City of Sedona Public Works Department

The City of Sedona, Arizona is issuing **Addendum #2** to the plans and specifications as originally issued at the time of solicitation for bids for the re-bid of **SR 179 Pedestrian Crossing at Oak Creek**. For any bid to be considered responsible and responsive, receipt of this addendum must be acknowledged.

This Addendum further extends the bid period beyond the extension issued under Addendum 1, providing a new date for which sealed bids must be submitted; responds to questions related to the project plans and specifications; and provides for revisions made to the project specifications and drawings.

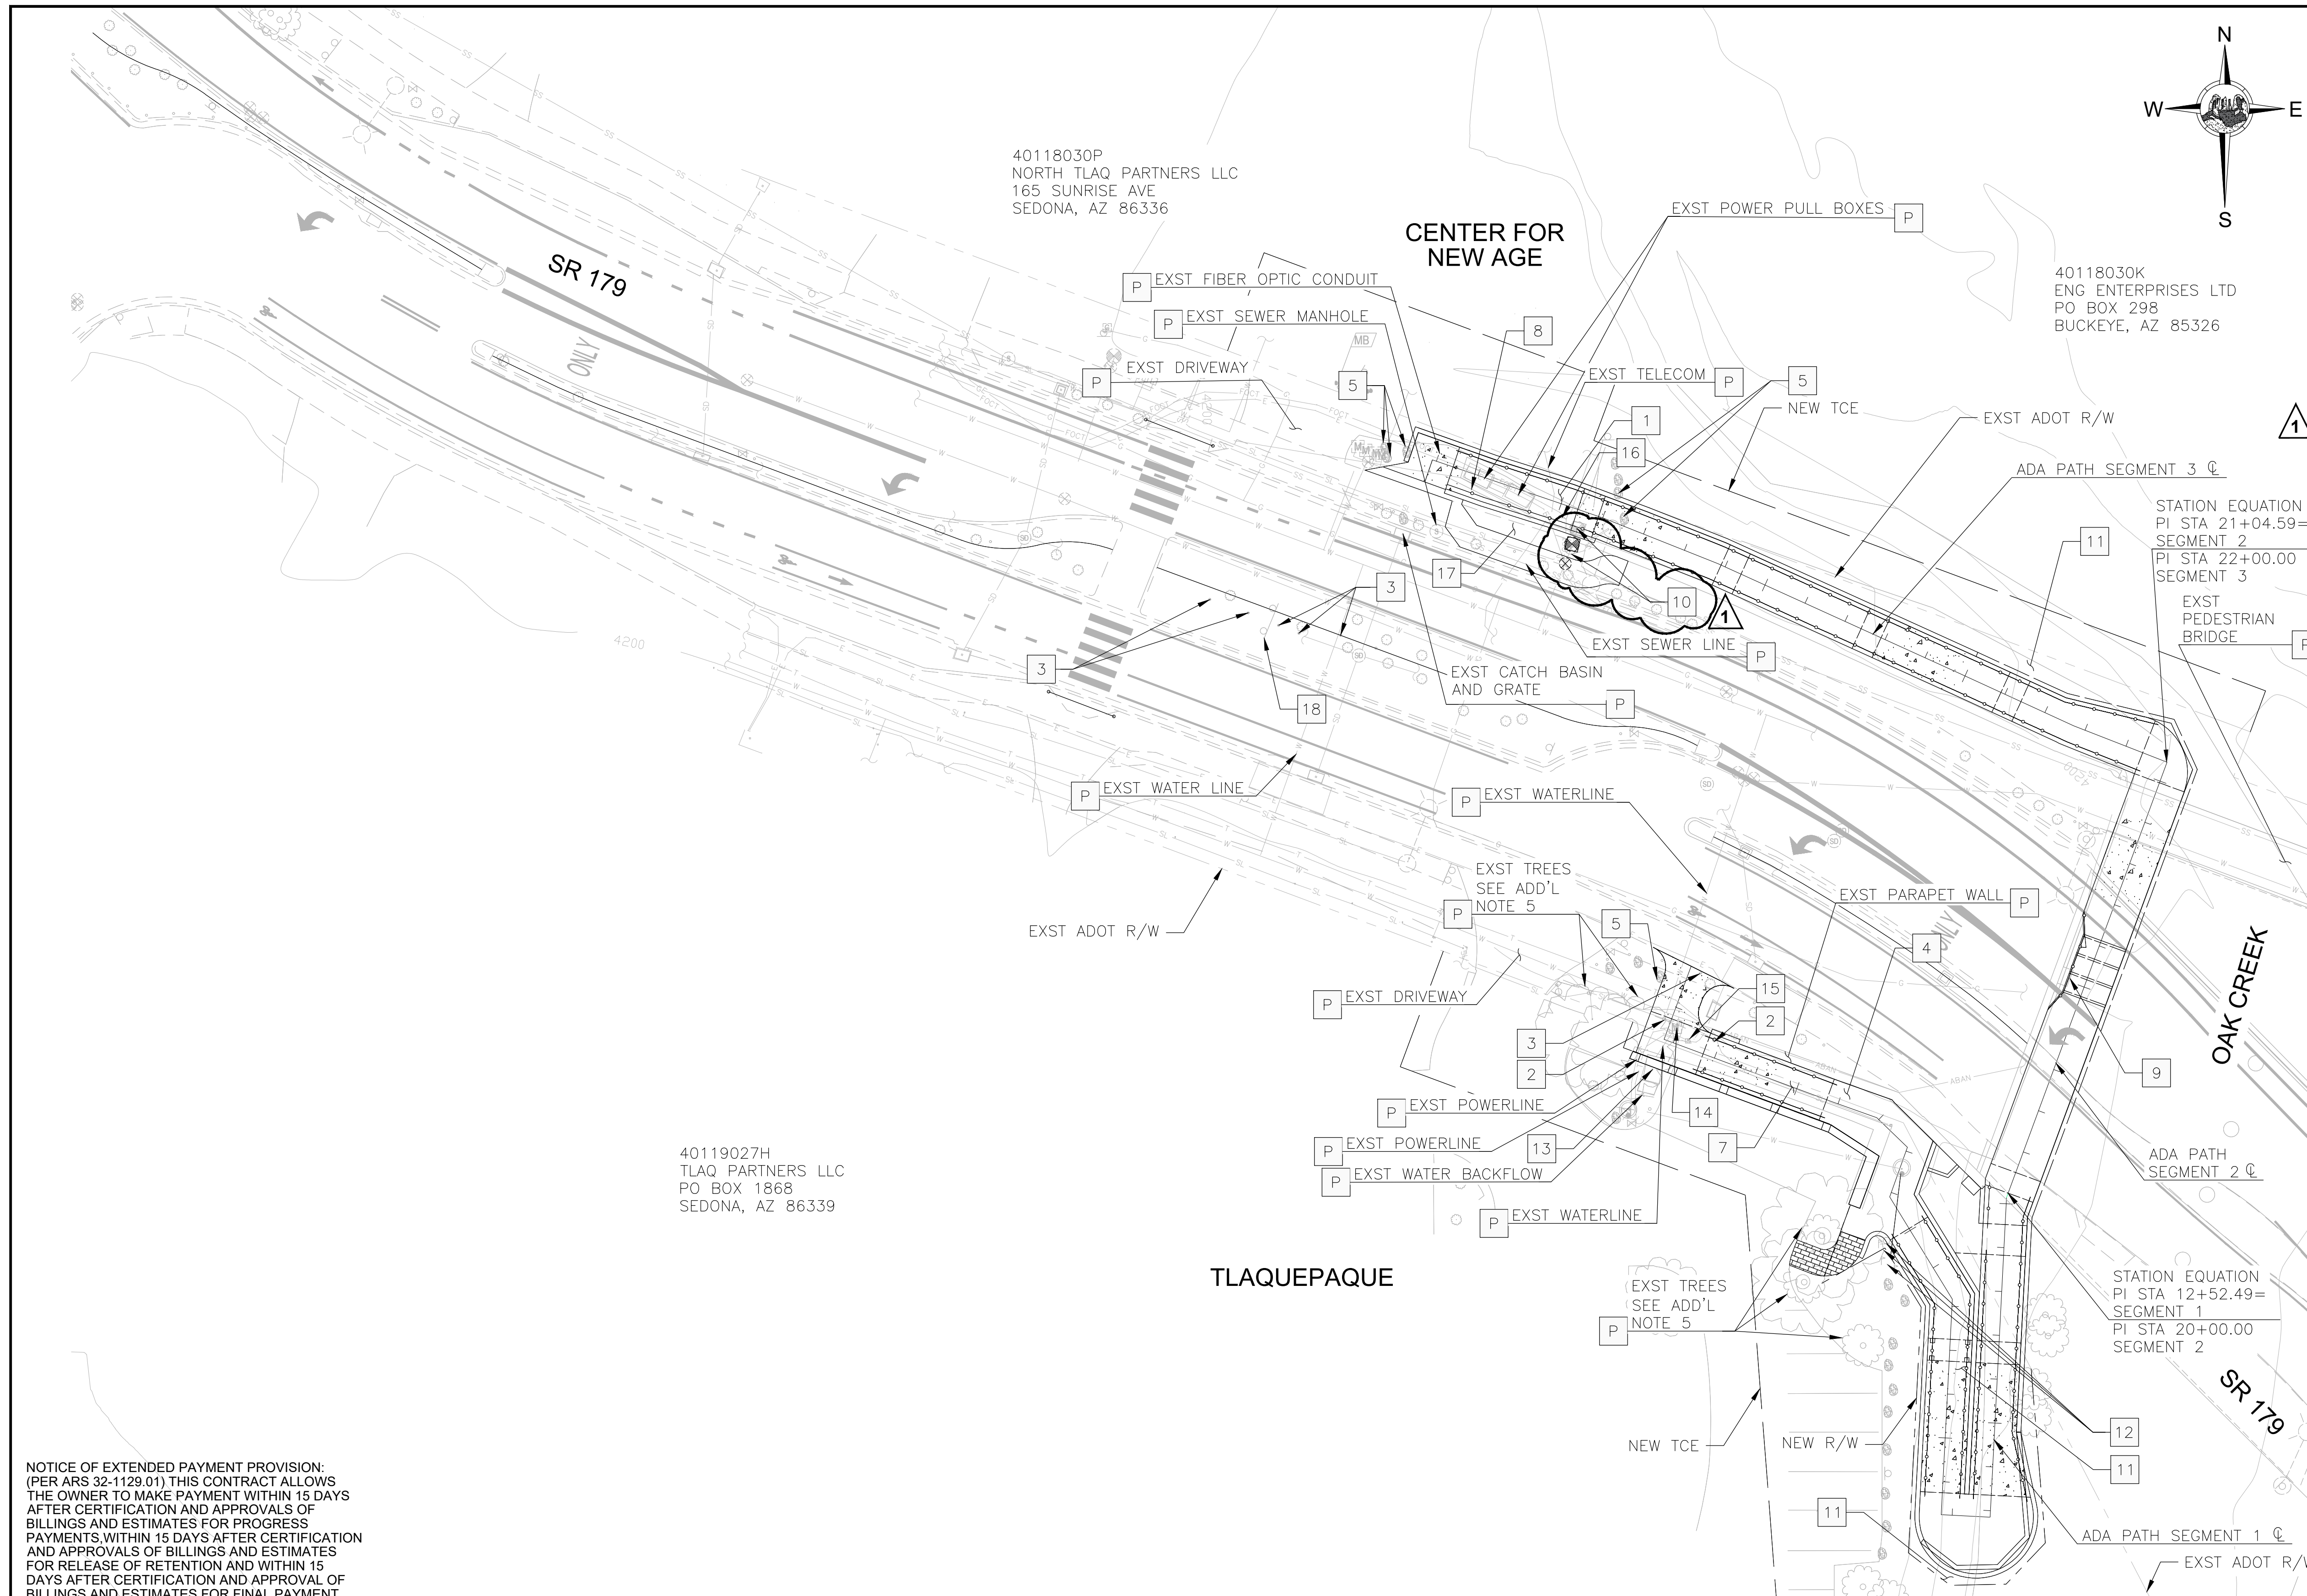
6.1. Replace plan sheet number 5 of 45 (C5), with the following:

Revised sheet 5 of 45 (C5) revision dated 3/3/2023, as provided in listed attachment 3.1 of this Addendum 2.

SHEET ID	
C6	
SHEET NO.	OF
6	45

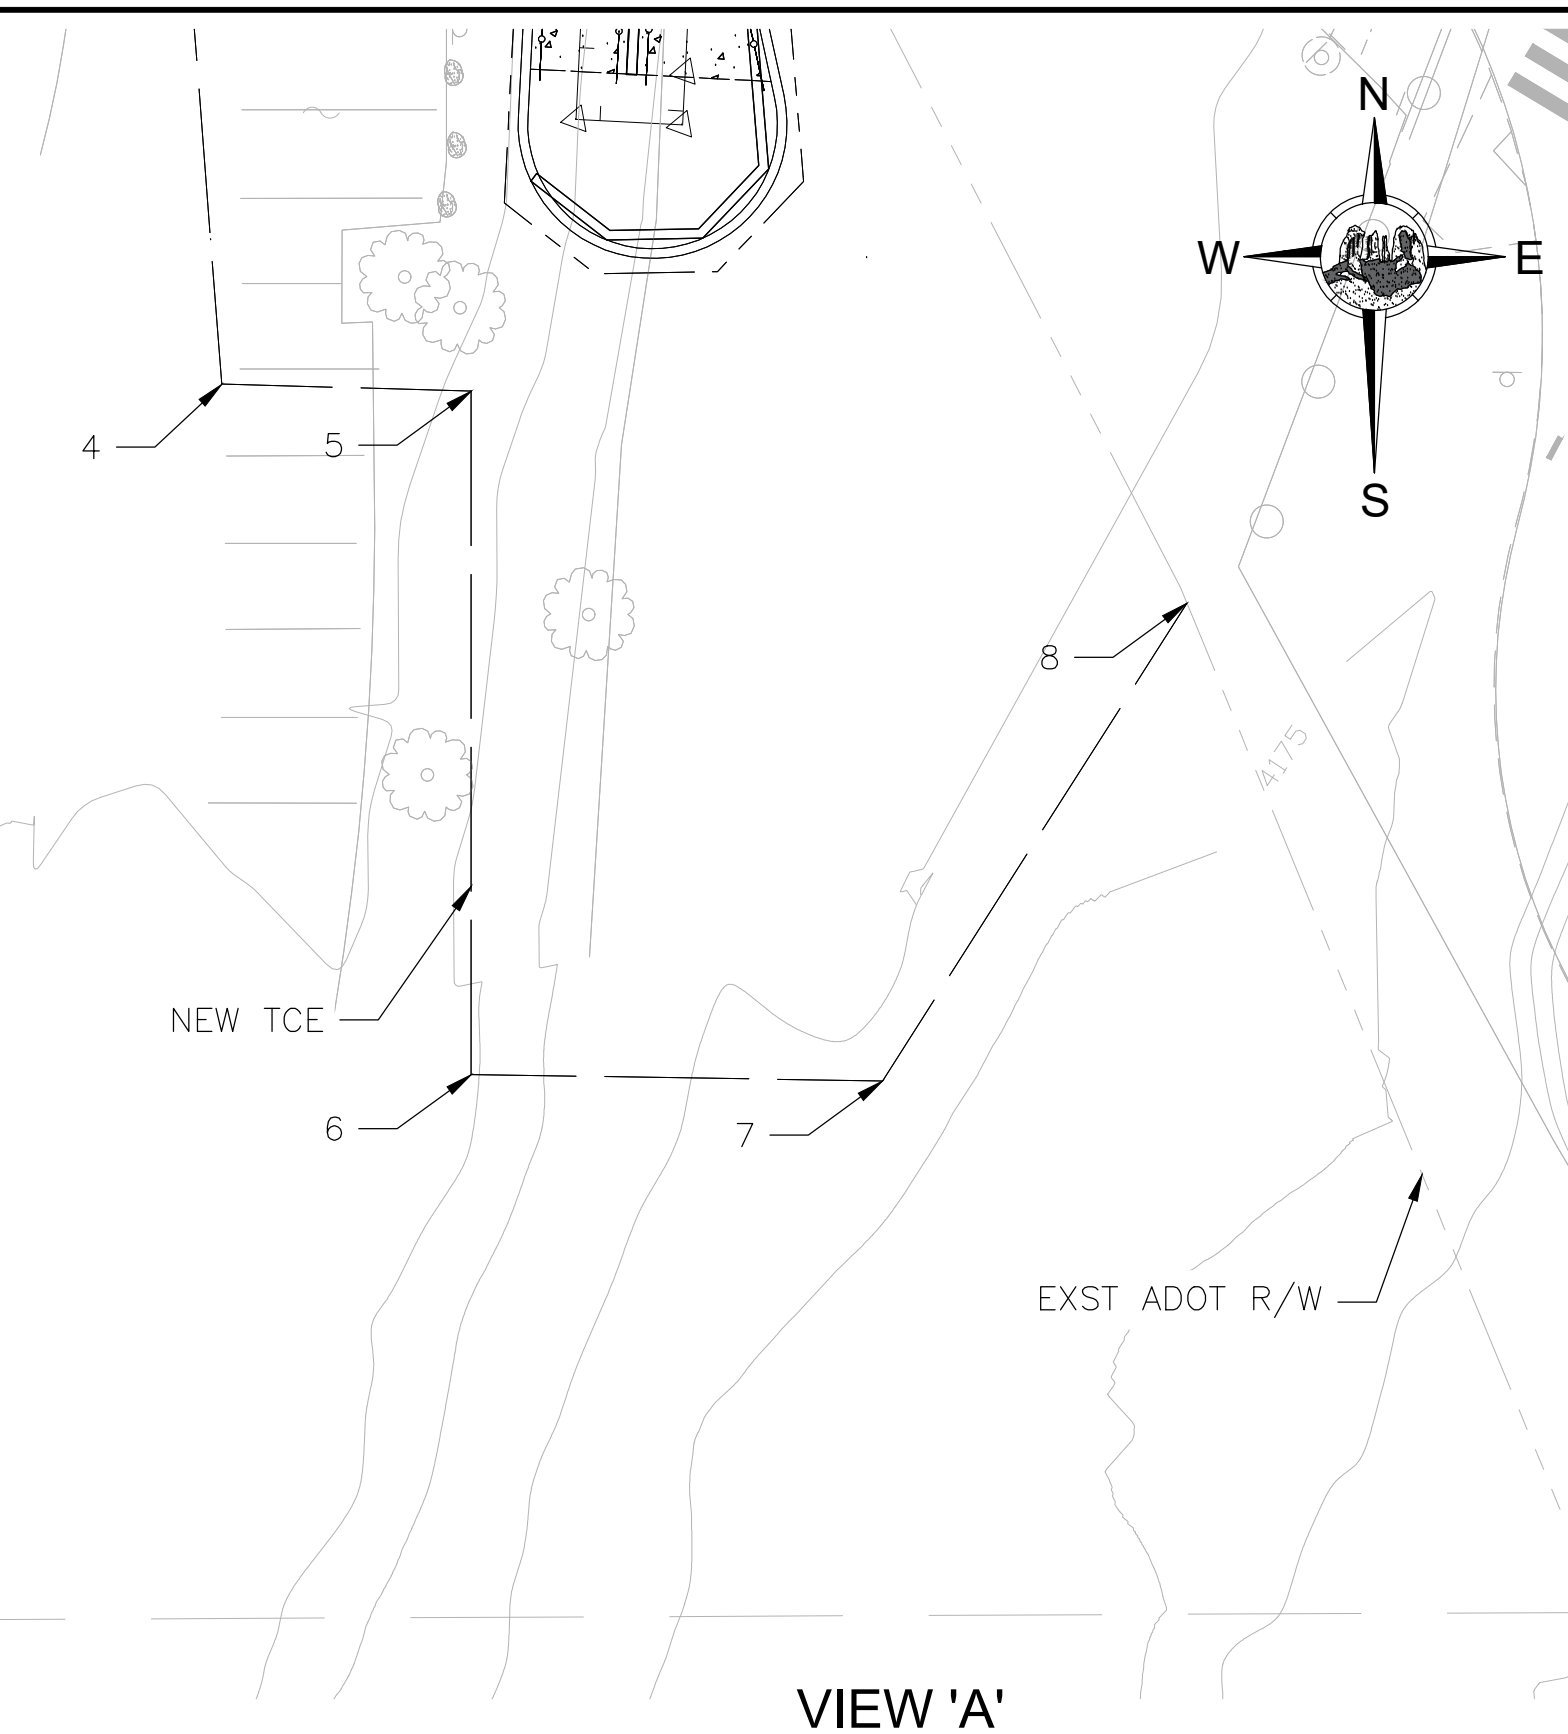
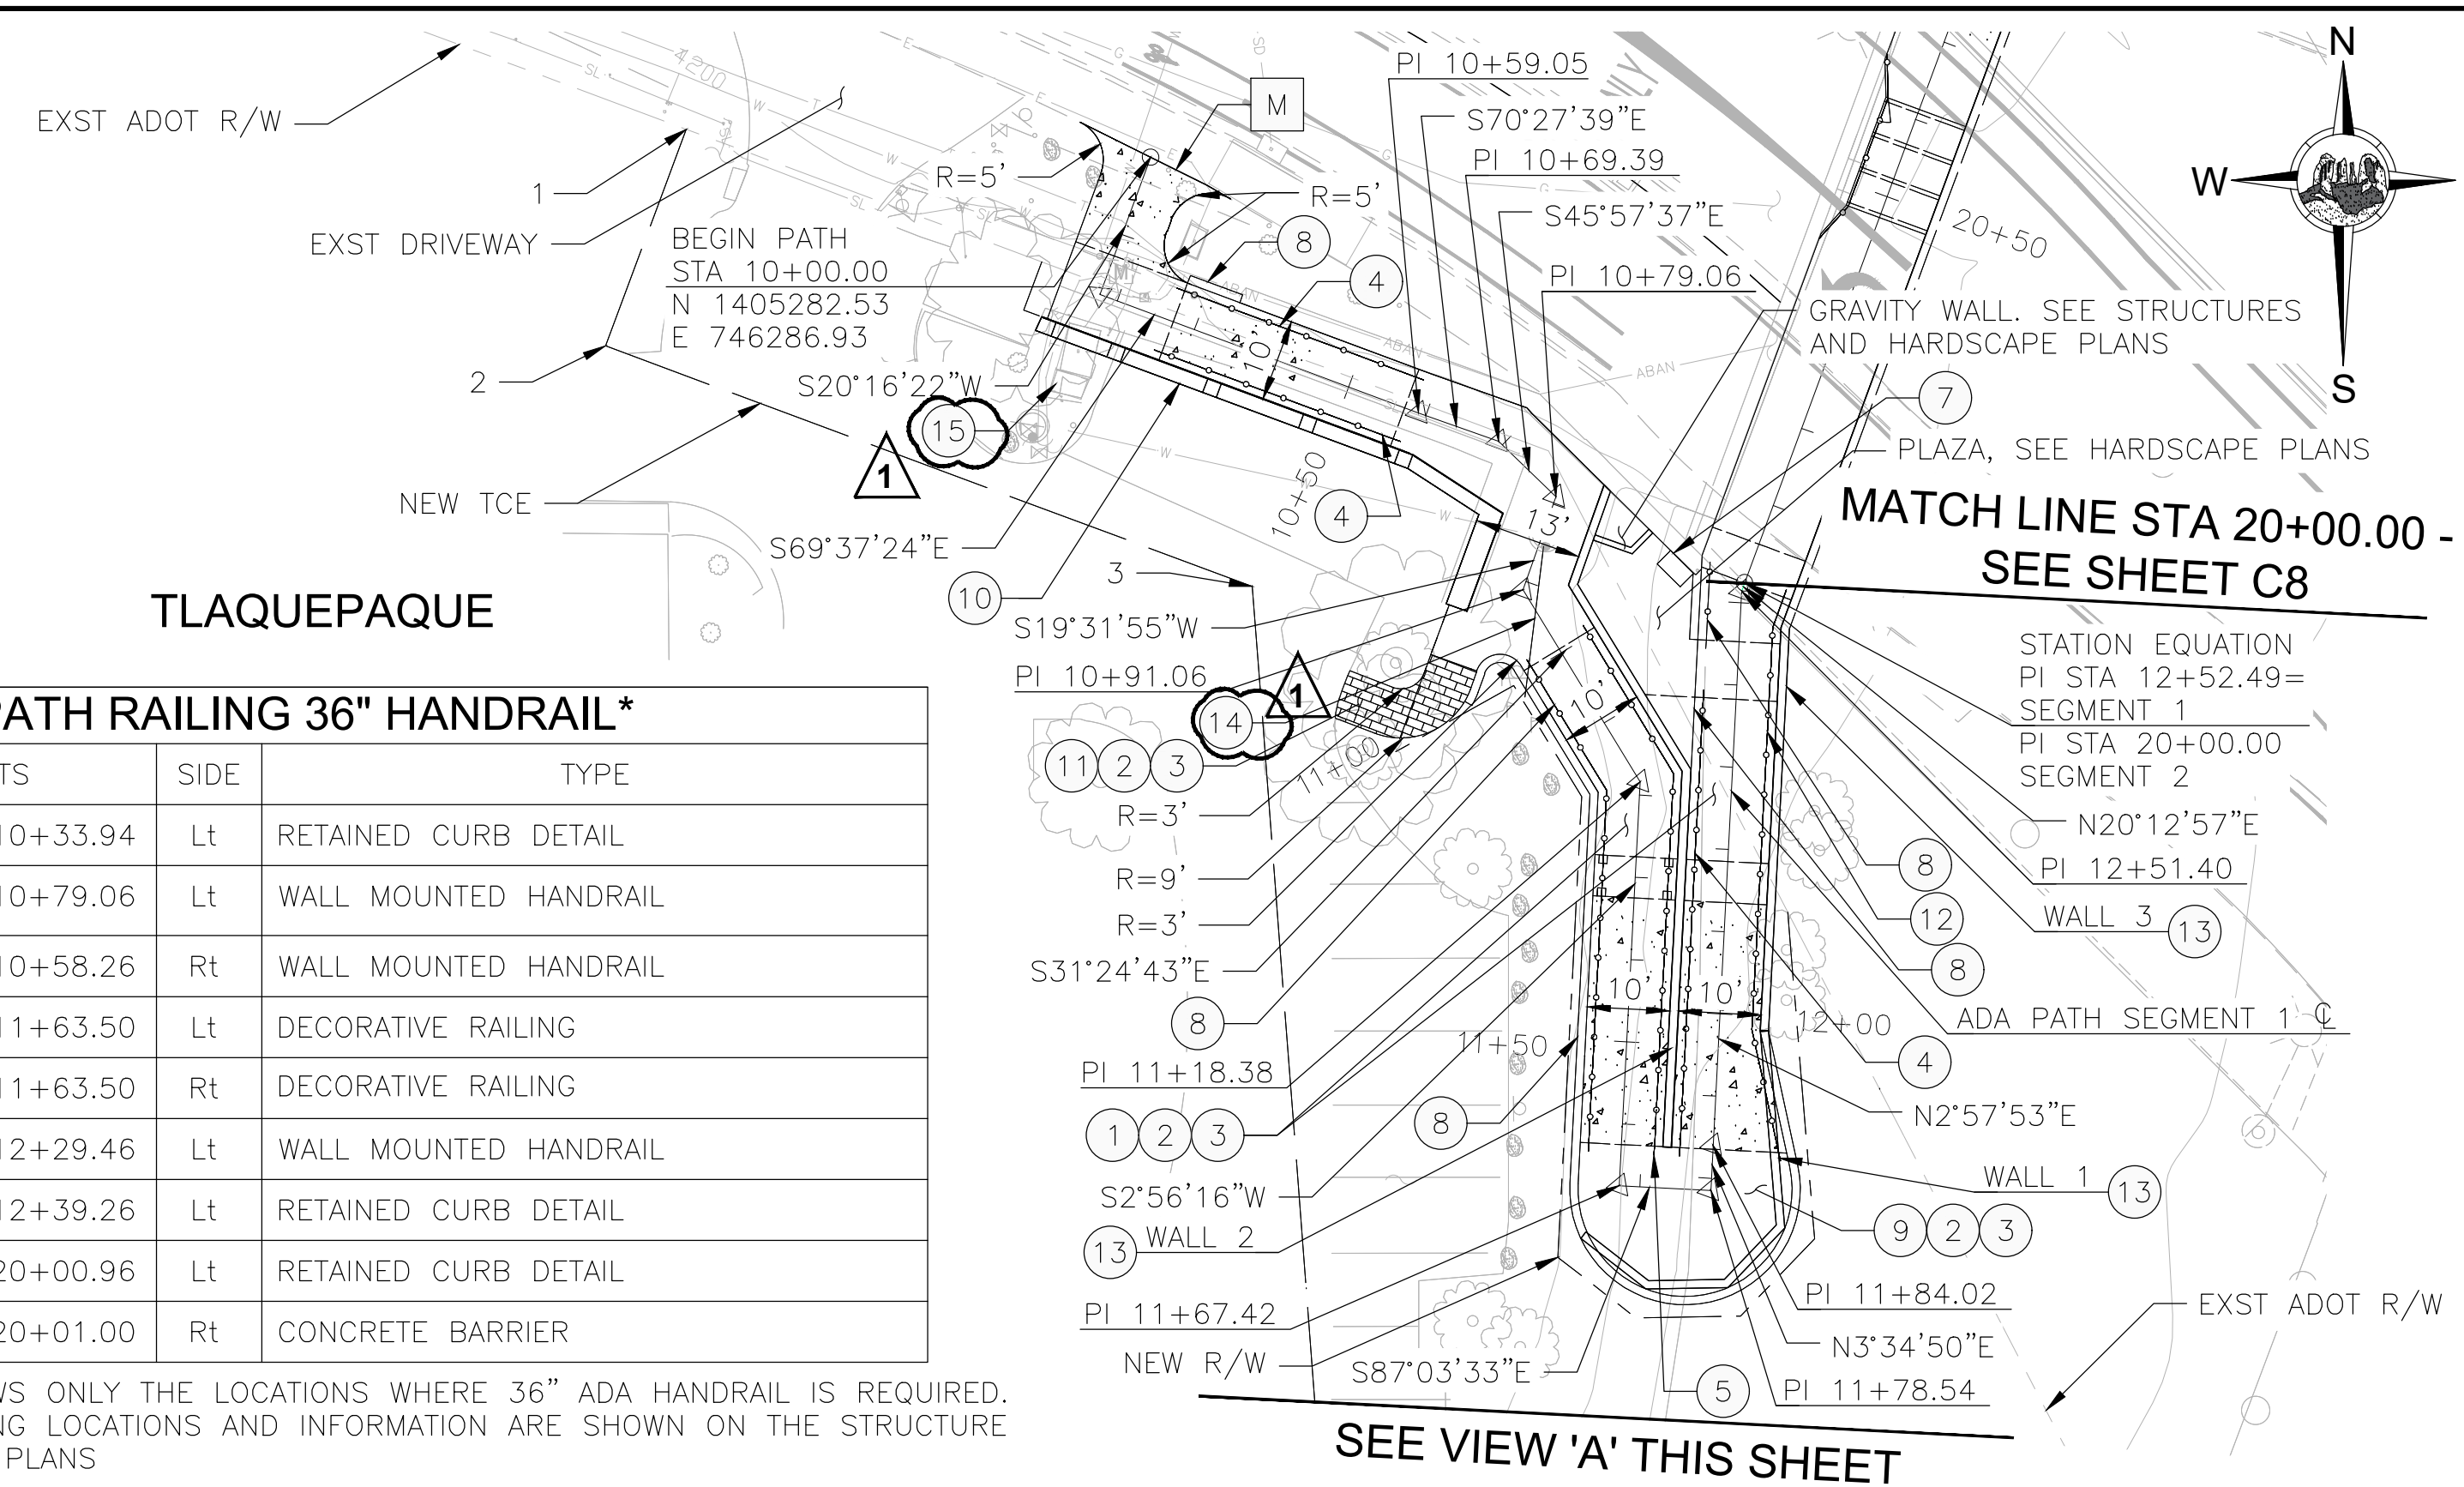
- 3.2. **Question** – On the Demolition Plan Sheet C6 there are the following construction notes with no associated bid items in the Bid Schedule; How should the contractor address these items?

- a. **"3 - Relocate Existing Irrigation Valve Per AWC Specifications."** Item added to specification for clarification.
- b. **"5 - Remove & Salvage Existing Decorative Boulder."** Item will be removed from Demo Plan, not applicable.
- c. **"14 - Remove Existing 2" Blow Off Assembly and Replace With 90 Degree MJ Elbow, 6 LF of 6" DIP, and Transition Couplings."** Item added to specification for clarification.

- d. **"6 - Relocate Existing Water Valve."** Specification has been updated for consistency and clarification.
- e. **"13 - Replace & Relocate Existing 2" Water Service Connection."** Item added to specification for clarification.

3.13. **Question** – Bid Item No. 2.2.4 “Remove and Salvage Existing Property Wall” and Note 7 on C6 “Remove Exist Property Wall” are in conflict. Should “and Salvage” be removed from the bid item description?

6.2. Replace plan sheet number 6 of 45 (C6), with the following:

Removal Notes 3 and 10 were revised.

Response – The Demo plan will be updated for Item Consistency with Specifications

Response – The CMU portions of the lower don’t need to be saved or salvaged, just the ornamental aspects of the wall, such as the wall column caps, flowerpots/containers and plants, and tile pieces making up the triangular ribbon along the top of wall.
